GM CUSTOMER CARE AND AFTERSALES
DCS3187
URGENT - DISTRIBUTE IMMEDIATELY

Subject: 14082A – Noncompliance Recall
Passenger Side Instrument Panel Performance
Revised Service Procedure / Customer Letter Added

Models: 2009-14 Chevrolet Express and GMC Savana 2500/3500 Series
Equipped with Front Passenger Side Airbag (AK5) and GVWR of
10,000 Pounds (4536 kg) and Below

SUBJECT: Passenger Side Instrument Panel Performance

3804499

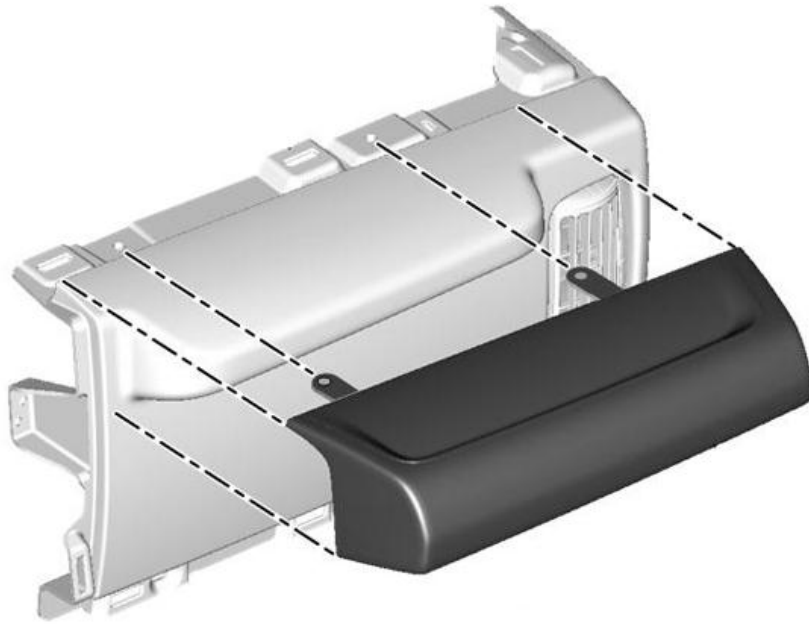
2. Remove the upper two screws that attach the instrument panel pad to the instrument panel bracket.

3. Inspect the brow assembly before installation to ensure the energy absorbing material is present.
